SEWAGE DISPOSAL SYSTEM

HOWARD COUNTY HEALTH DEPARTMENT

SUBDIVISION Camden Downs LOT 11 ROAD 15616 Thistle Downs Court

PLOT PLAN
LOT 11
CAMDEN DOWNS
SECTION 1, AREA 1
4TH ELECTION DISTRICT
HOWARD COUNTY, MARYLAND
SCALE : 1"= 50' 2-11-91

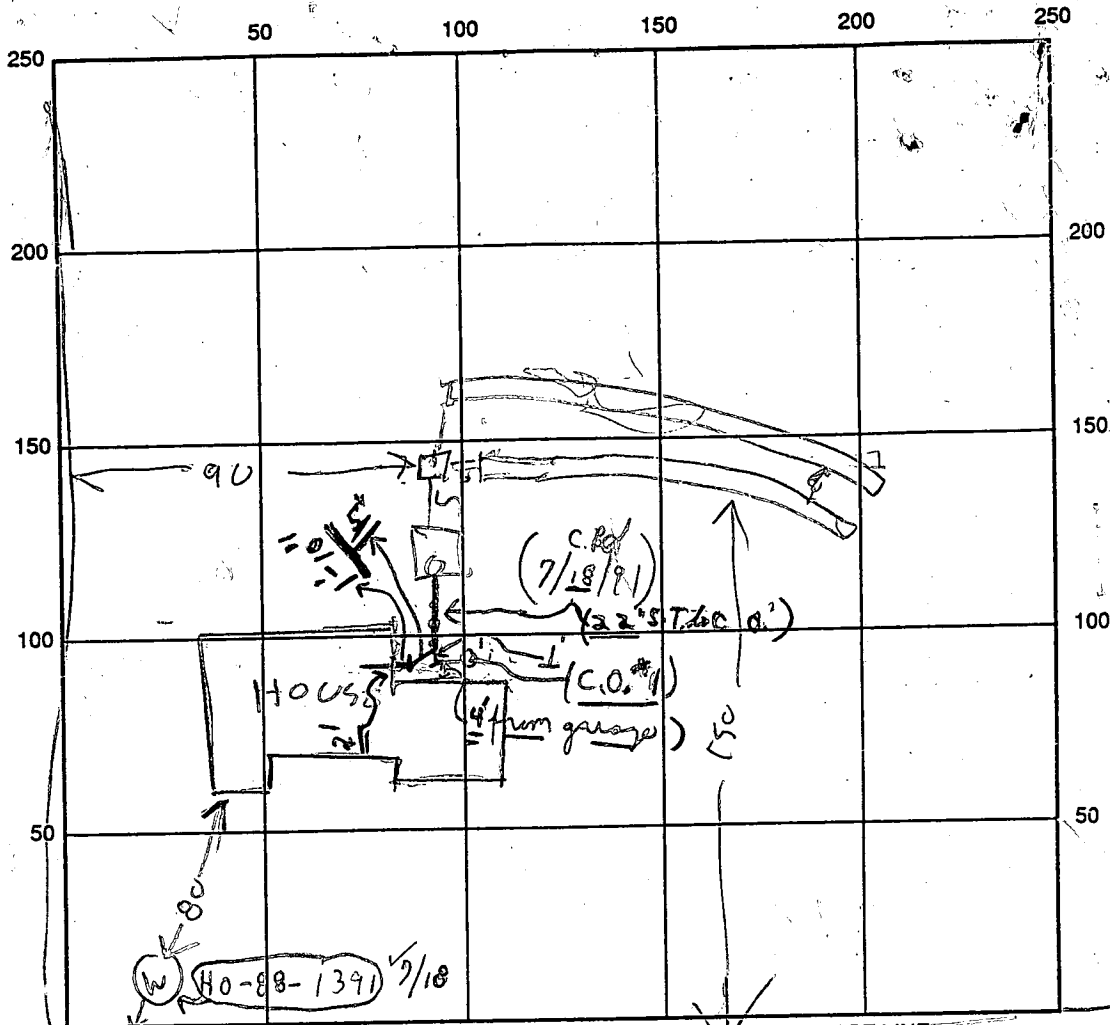
NEEDS CAP ON CLEANOUT
HOUSE

7/18/91 HOUSE CONNECTION OK Needs cap @ C.O. near home - Patrick

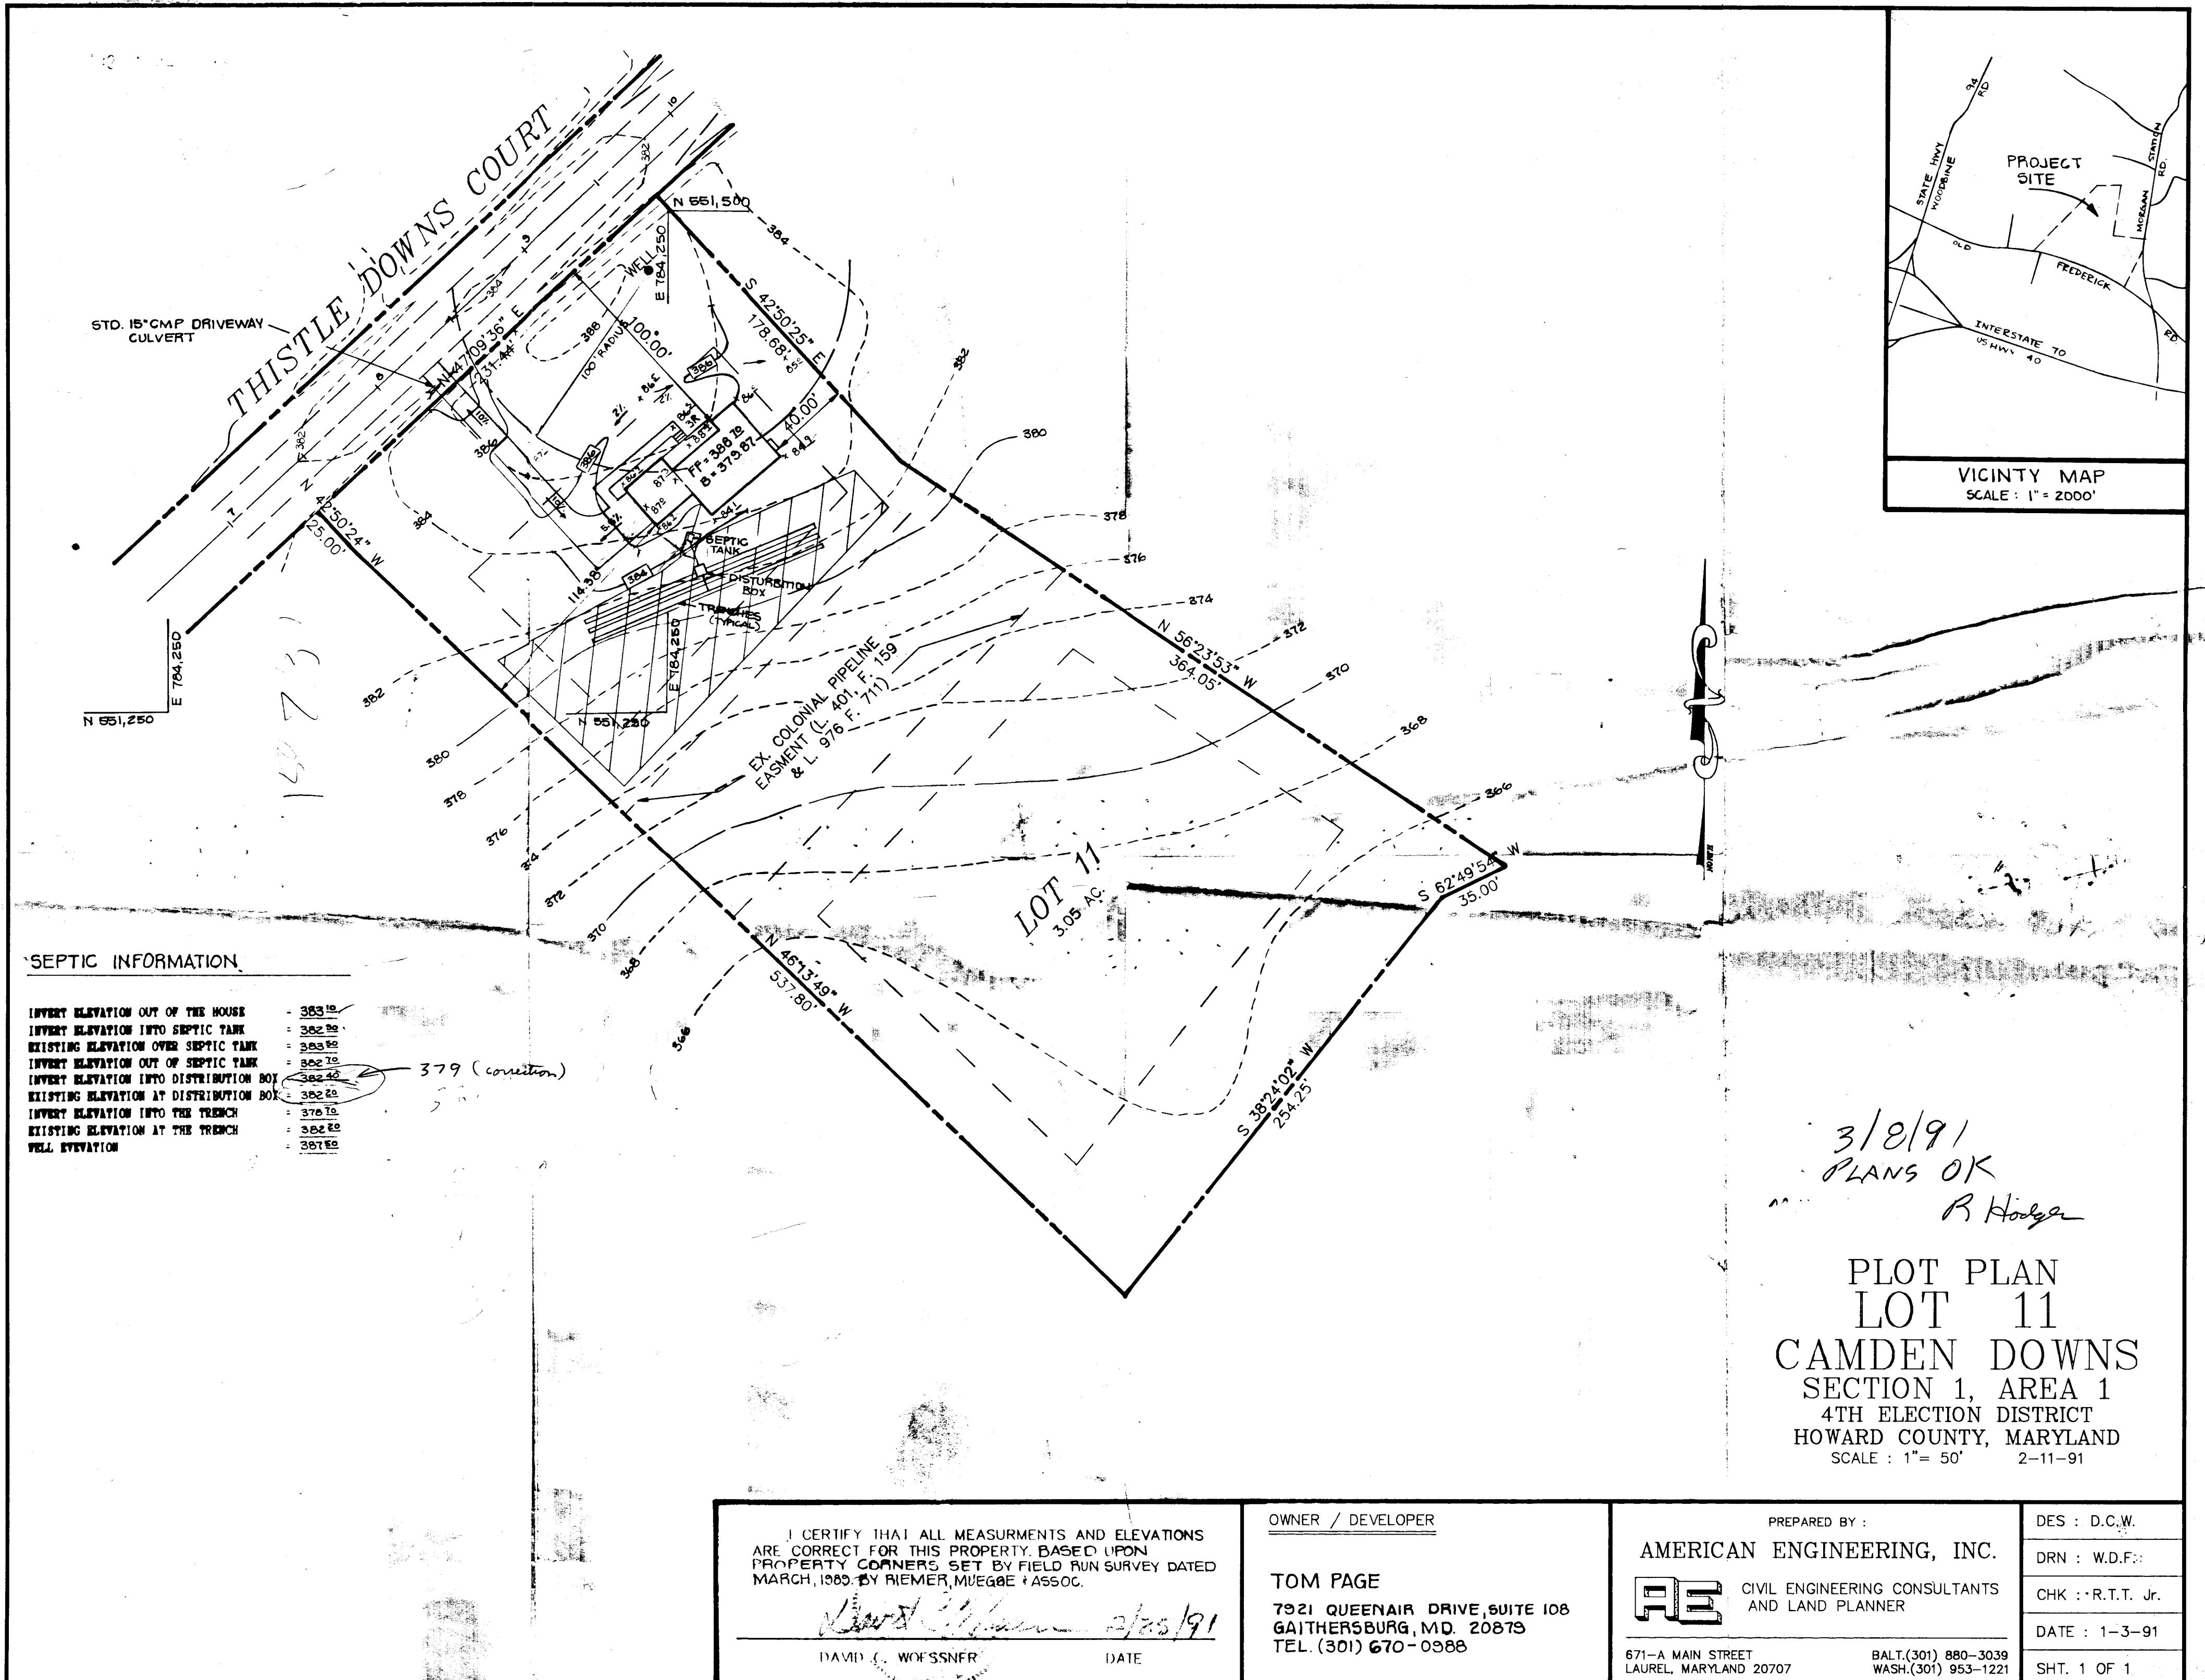
301-948
2793
Tom Page fax
6/28/01 EX. S.S.
INSTALLED AS SHOWN
w/HANDSKETCH. OK TO
REMOVE SHADED AREA
FROM EX. SEWAGE
EASEMENT; ~10,400' REMAINS MR

DECK OK AS
SHOWN MR
7/5/01
